SERVICE BULLETIN

APPLICABILITY: 2019MY Ascent “Touring” Models

NUMBER: 12-255-18

SUBJECT: Rear Door Handle Frame- Design Change

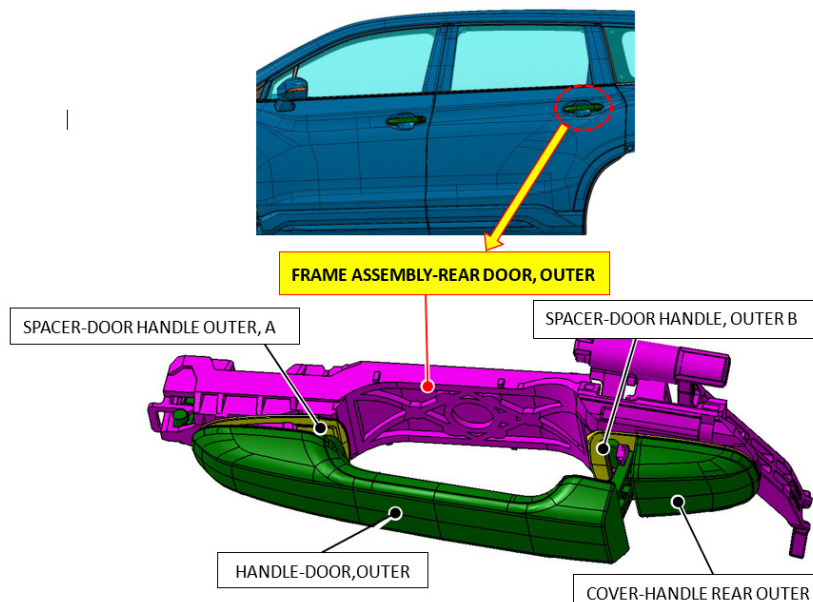
This bulletin outlines a design change made to the inner frame assembly used with the silver (“chrome”) type outer door handle to improve its reliability.

NOTE: The changes were made to the Frame Assembly, not the outer door handle. See illustration below.

Description	Part Number
FRAME ASSEMBLY- REAR DOOR OUTER RIGHT	62142XC00A
FRAME ASSEMBLY- REAR DOOR OUTER LEFT	62142XC01A
